Ref: Part Change — Rotoflo Molex Connector to be replaced with Deutsch Connector

From: Spectra Watermakers

To: Spectra Watermakers - Licensed Distributors **Date:** 2/2/2023

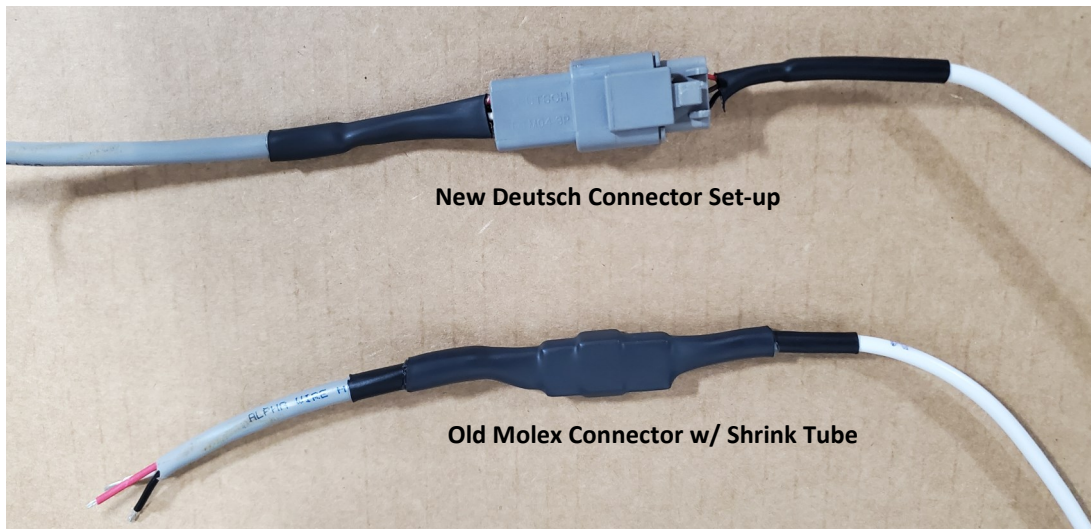
In our efforts to improve the quality of our systems and to aid in troubleshooting, we have decided to change out the Molex connector for the Rotoflo sensor to a watertight 3-pin Deutsch connector. This will be implemented on the entire marine Connect product line moving forward.

Molex connections can be troublesome, and if not crimped correctly can lead to wasted time troubleshooting. Furthermore, the connection is not watertight, and the shrink tube applied over the top must be cut to replace the Rotoflo. This shrink tube is often not replaced by the end user leaving their systems vulnerable to moisture.

If a customer's existing Rotoflo sensor fails in the field and they order a new one (**EL-SSR-IFM & EL-SSR-IFMLR**), the Rotoflo will come with bare wires for re-installation.

If customers want the new Rotoflo to come with Molex connectors, please use:

SUB-MPC-IFA (in place of EL-SSR-IFM)

SUB-MPC-IFAVT (in place of EL-SSR-IFMLR)
